**DEVIATION REQUEST
AND DECISION FORM IN
ASSOCIATION WITH A
REQUEST FOR A PUD
MODIFICATION FROM
THE ECM**

Project Name : Urban Landing Preliminary Plan

Urban Landing

FIRE TRUCK SIZE:
8.3' WIDE
43.4' LONG

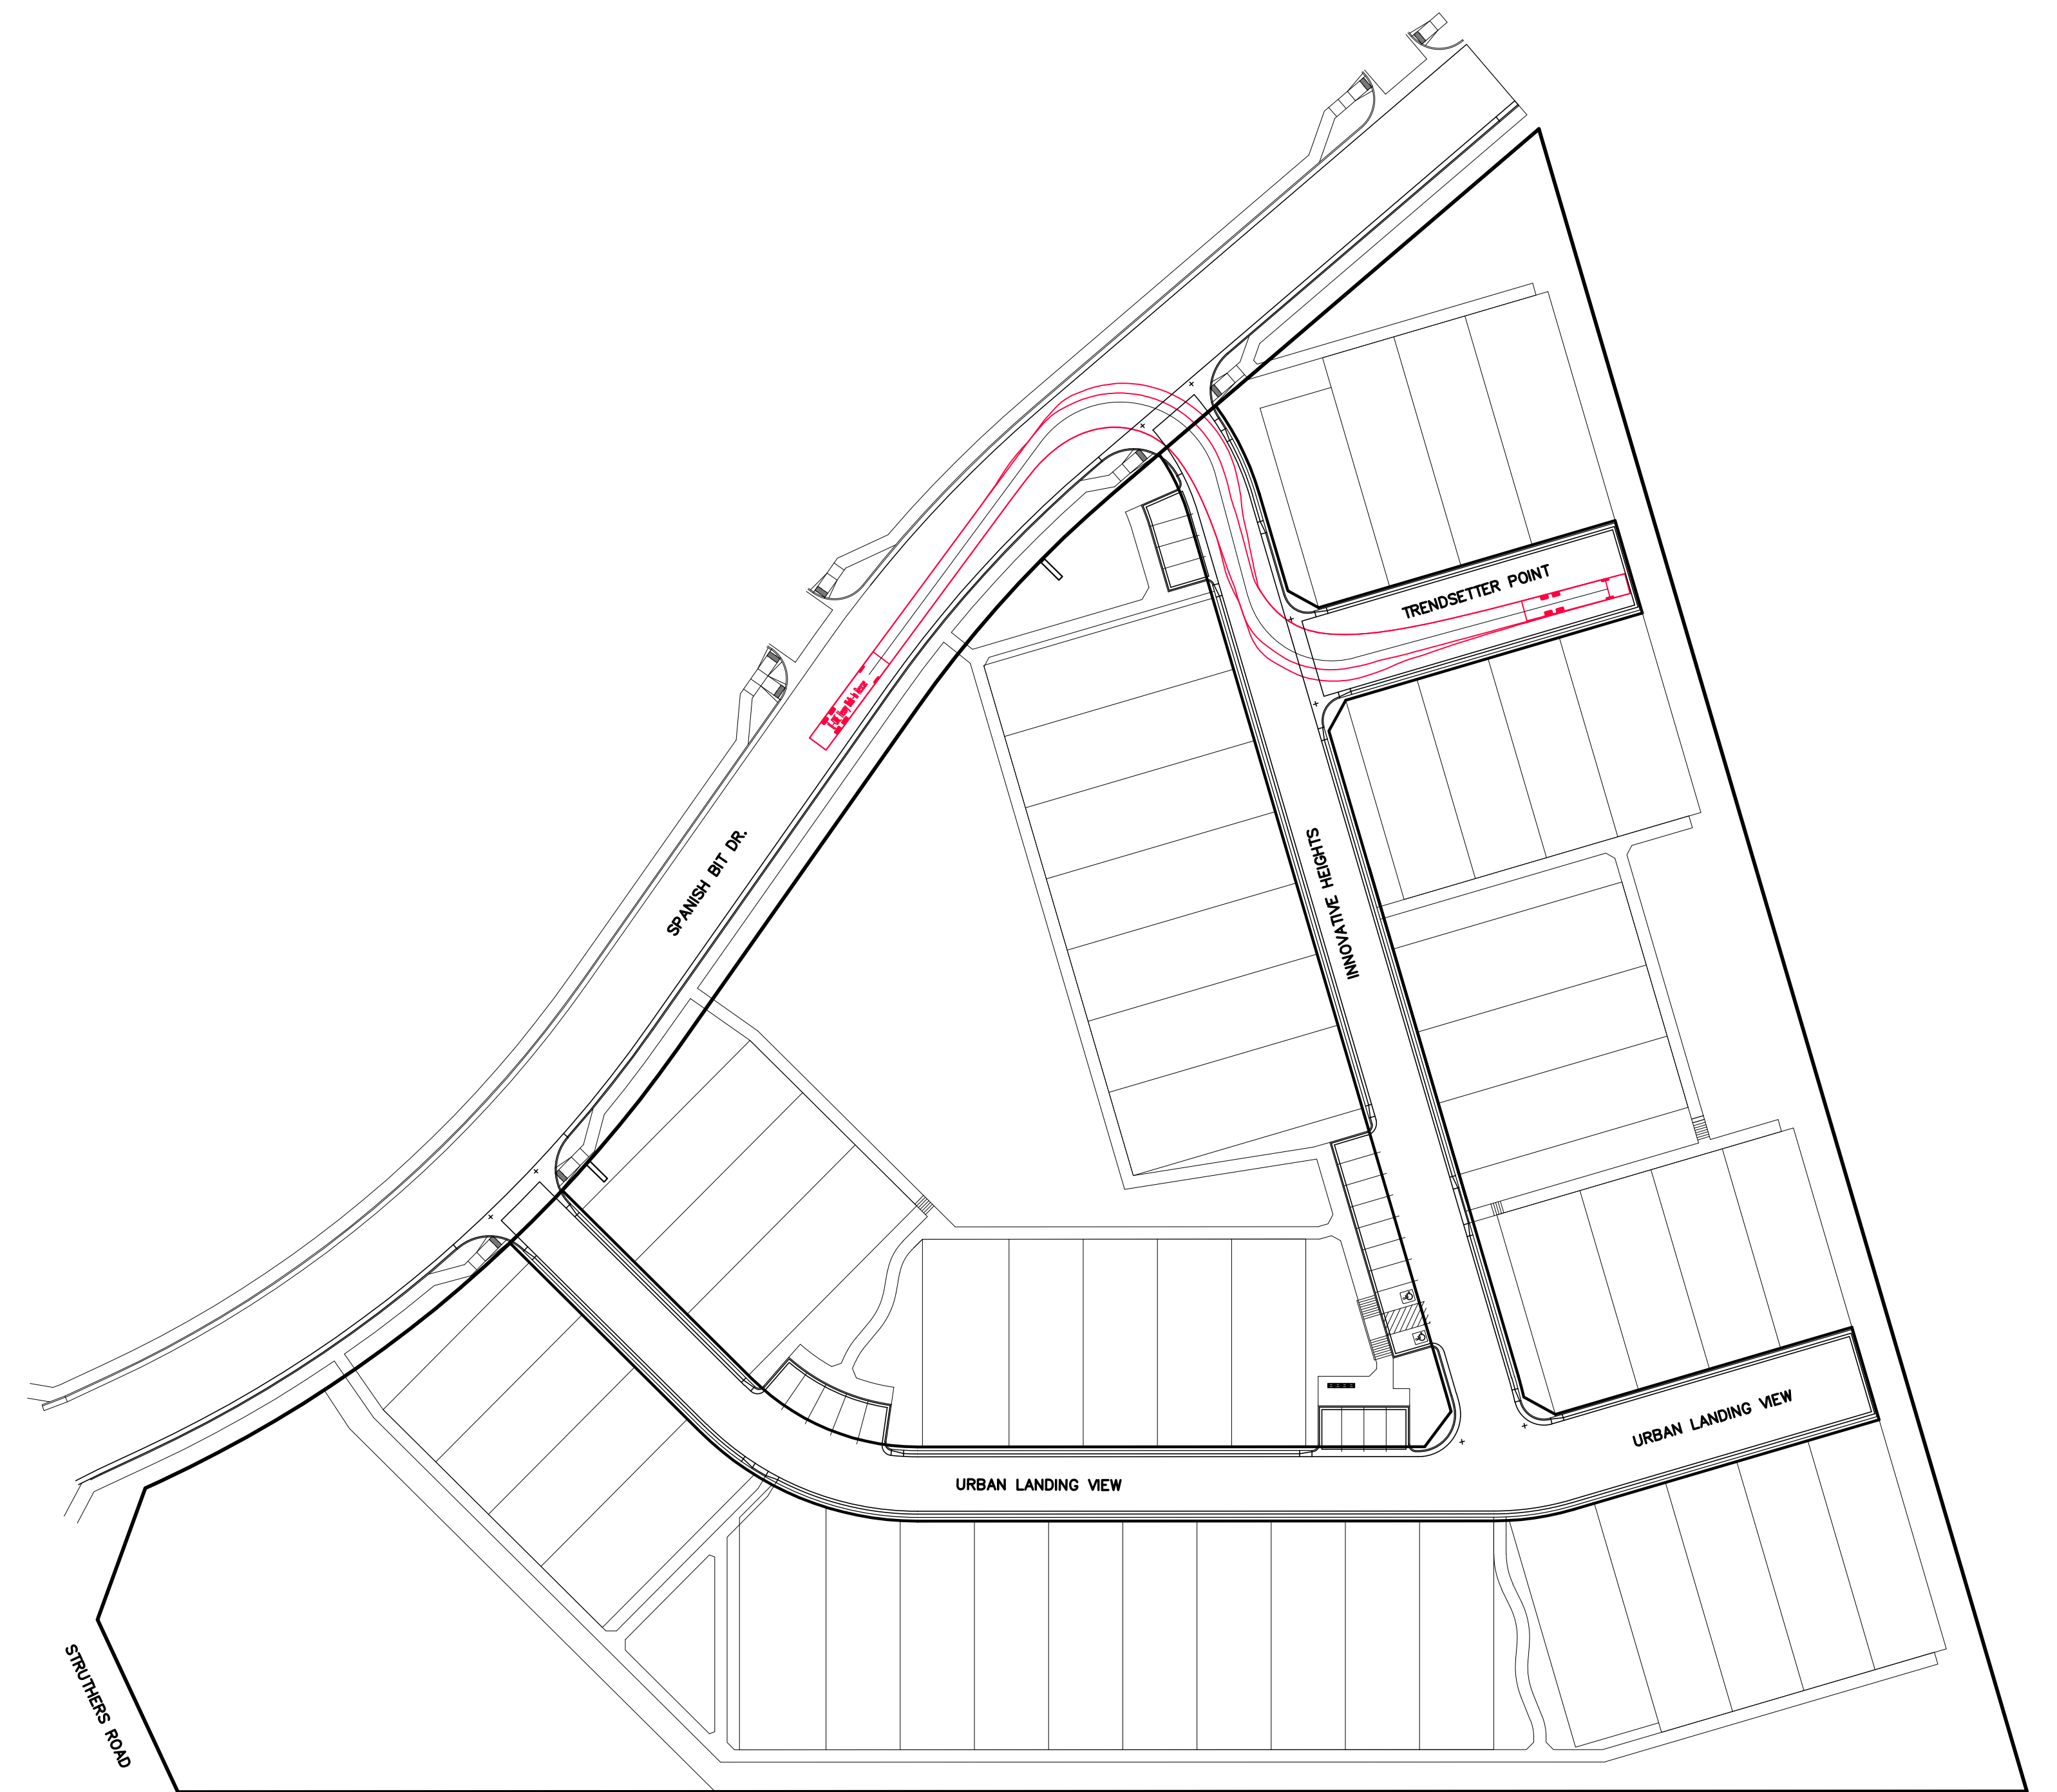
Awesome! Thanks again for the quick turn-around.
So you have no issues with the short dead-end roads?

No. They are short enough that it doesn't trigger a turnaround in the fire code.
